Access Compliance Report

Public Rights-of-Way

(Pedestrian Signals)

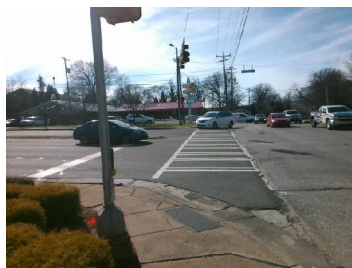
PROW/ADA: R209.1, TMUTCD 4e.08, R410.6, R404.2, R404.3, R406.2,

Possible Solutions: Replace Signal Push Button With APS Button on New Post.
Remove & Replace Sign. Remove & Relocate Sign.
